Model: **BKM-101C, *BVM-14M4DE***

Subject: **LOSS OF SDI SIGNAL W/B, COMPONENT SIGNAL SHADING**

Serial No: **2,023,651 AND HIGHER (BKM-101C)**
2,012,462-2,013,011 (BVM-14M4DE)

Figure 1

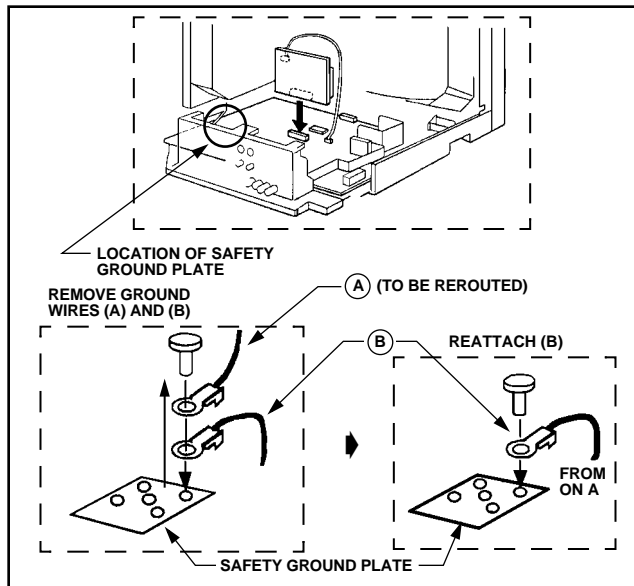
1. Remove one screw attaching the following two ground wires to the safety ground (earth) plate.
 - (A) From TP310 on the BB board
 - (B) From PIN308 on the A board
2. Reattach (B) to the safety ground plate.
3. Reroute ground wire (A) as close to the Q board as possible, attaching it and ground wires (C) and (D), from the SDI board, to the bracket of the focus plate.
4. Use two purse locks to secure ground wire (A) to the two cable harnesses between:
 - (A) CN306 (Q board) and CN301 (A board)
 - (B) CN401 (A board) and CN701 (C board)
